# Optimization Review Report

**Saunders Supply Company Superfund Site  
Suffolk County, Virginia  
EPA Region 3**

FINAL – August 2016

**Prepared by ICF International**

Downgradient HRSC Transect

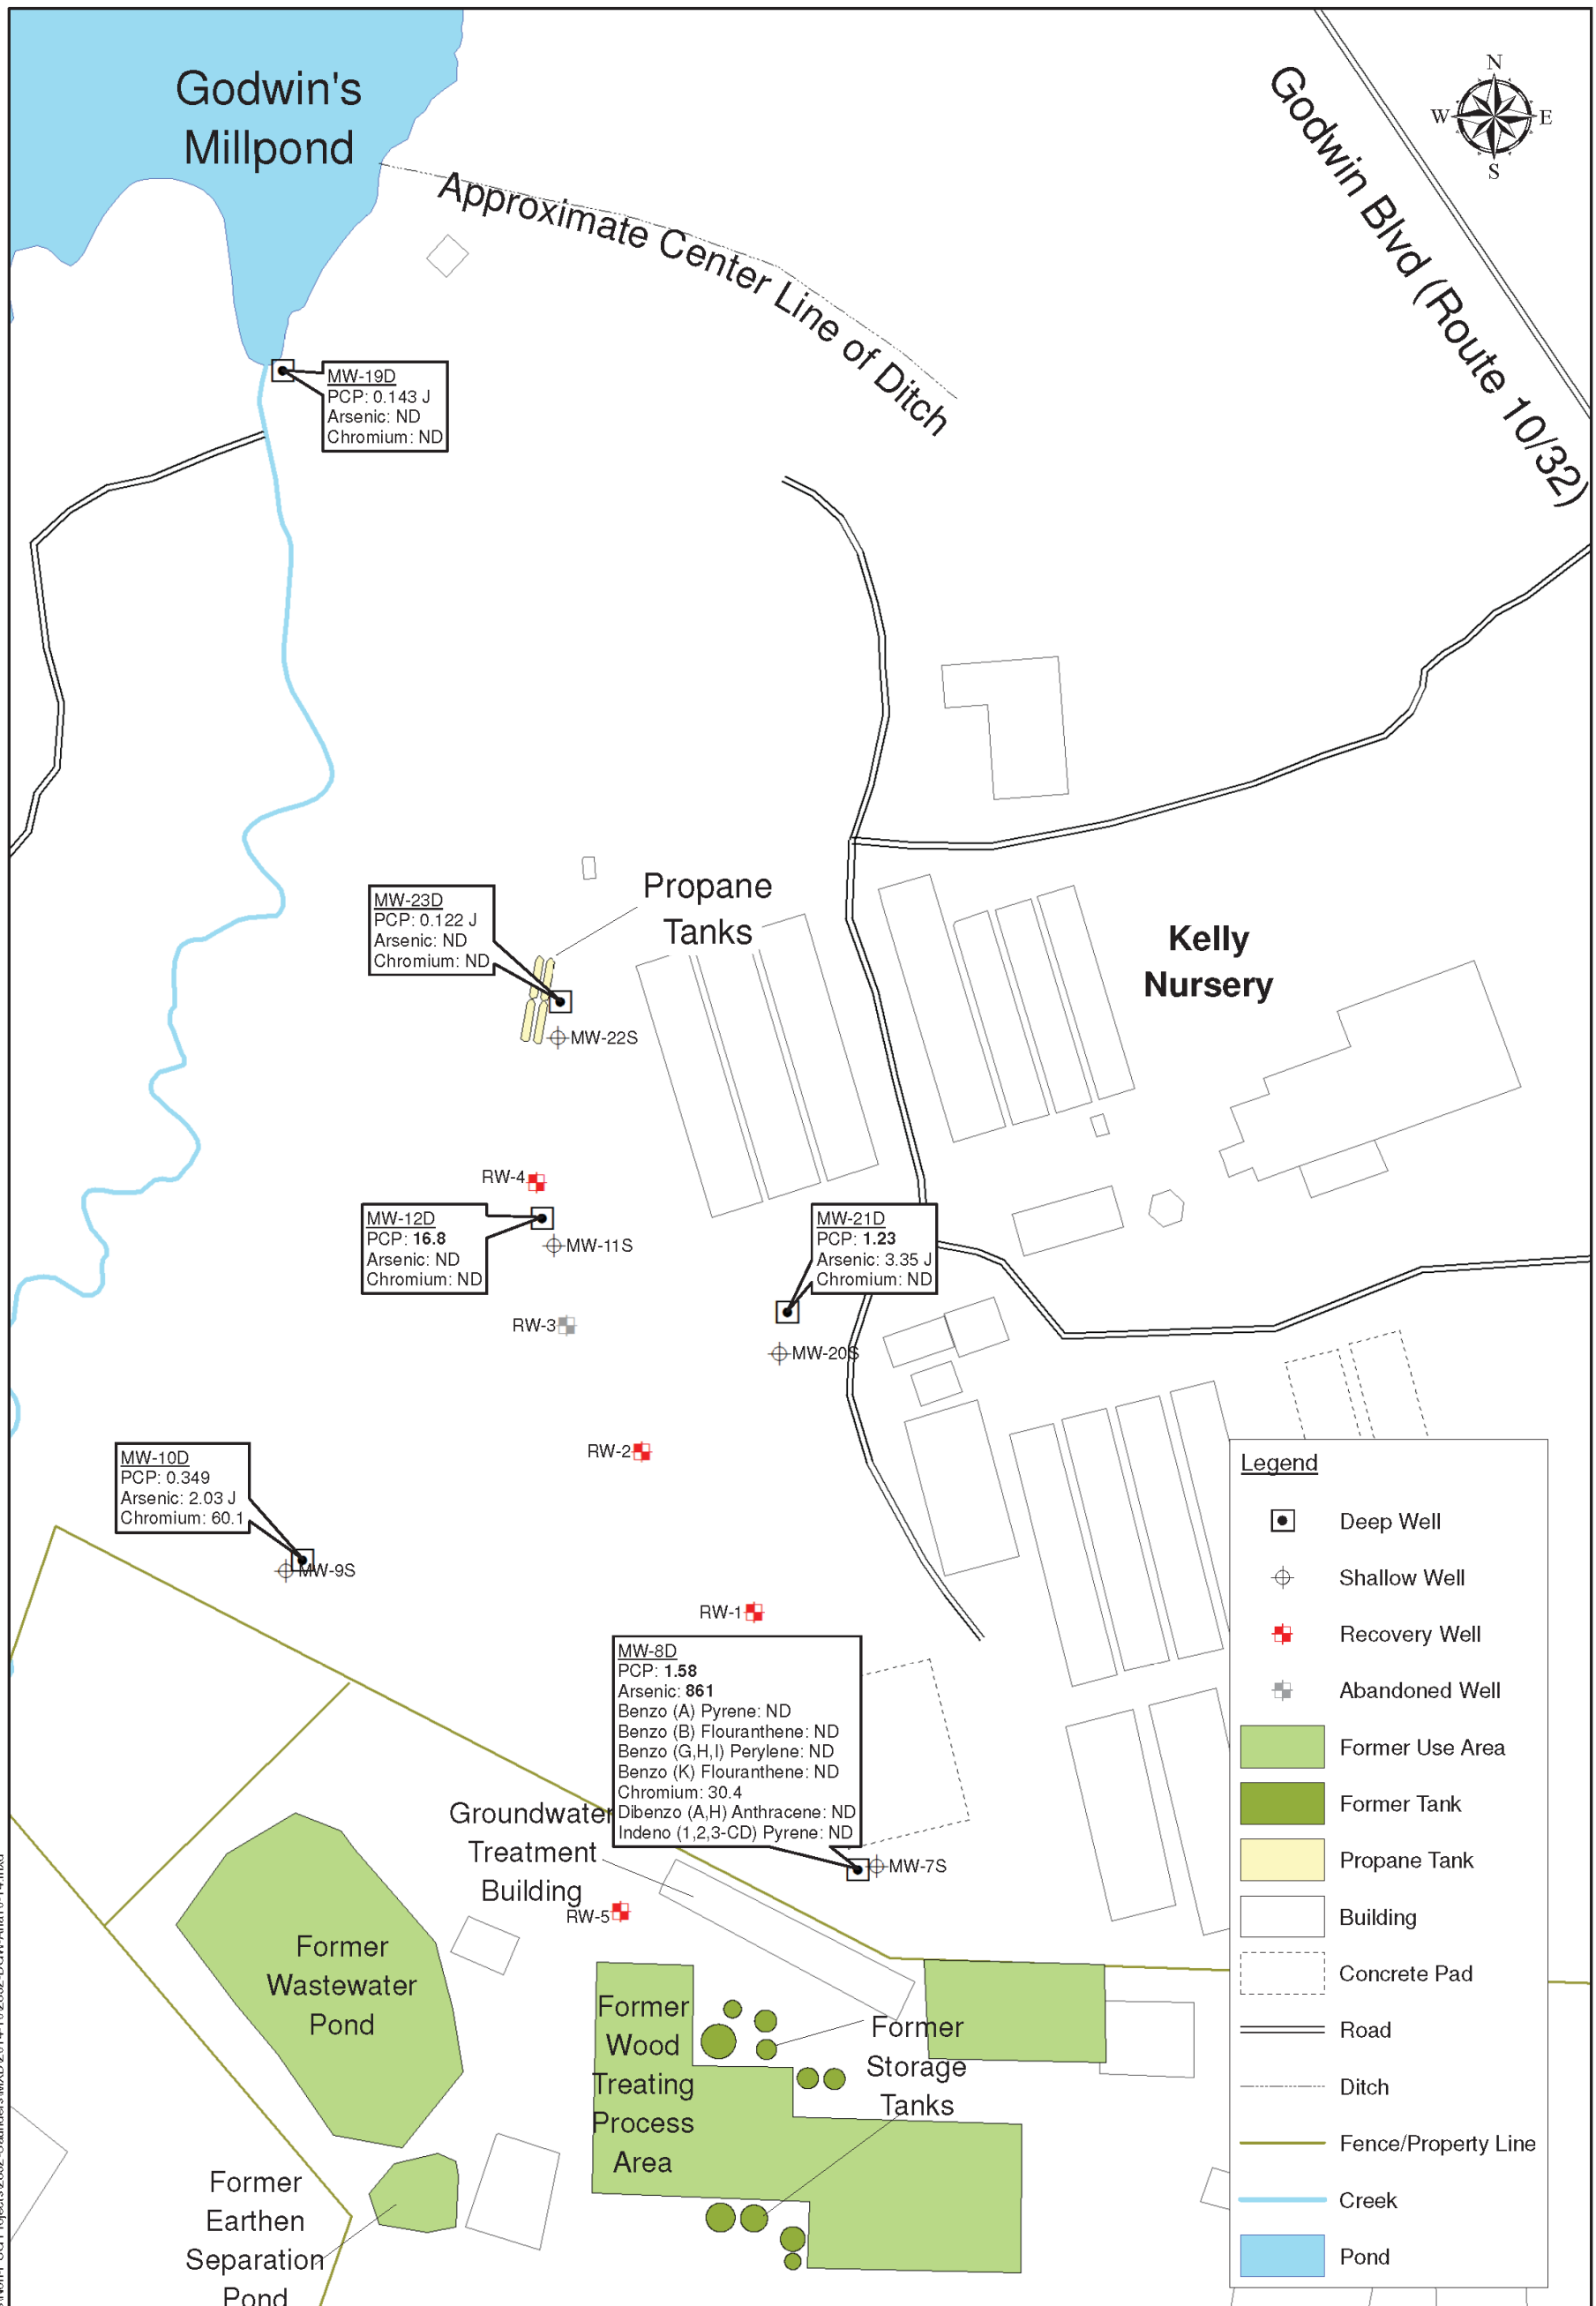
HRSC data will help accurately depict the footprint of subsurface contamination in order to apply targeted actions, should they be deemed to be necessary. The optimization review team recommends initiating the HRSC in the vicinity of RW-5 on the Saunders property using an east-west oriented transects near the Former Wastewater Pond source area and Former Wood Treating Process Area. Real time data, combined with site action levels, can be used to identify the western edge of the transect. If data support further characterization, parallel transects can be made further north, within the Kelly property. A second location for an east-west HRSC transect is recommended on the Kelly property between the fence and MW-7S/8D to characterize the Conical Burn Pit source area and Former Wood Treating Process Area. In each of these locations, discrete soil and groundwater samples should be collected for PCP, arsenic, and chromium analysis in the Columbia and upper Yorktown Confining Unit to assess contaminant mass and transport. The approximate location of these transects is shown in Figure 6 in Appendix B.

The optimization review team also recommends HRSC of the downgradient plume area (see Figure 6 in Appendix B) to support estimation of contaminant mass, build a detailed conceptual model of the plume, and evaluate the effectiveness of potential refinements to the remedy described below in Recommendation 5.3. Boring logs from continuous direct-push technology (DPT) profiling of the Columbia aquifer during the 2005 Deep Groundwater Investigation (CDM, 2005) shows thick layers of sand locally broken by lenses of fat clay. The 10-foot well screens in the existing monitoring wells, and the 15 foot screens in the existing recovery wells expose large sections of the Columbia aquifer and lesser parts of the upper Yorktown Confining Unit, and may contain stratified flow zones separated by less permeable zones. Contaminant flow may be concentrated in thin permeable zones and the existing screens may not provide fine enough resolution to focus removal on the preferential transport zones for PCP and metals. High resolution groundwater contaminant and hydraulic profiling can be used to increase the vertical resolution of contaminant distribution.
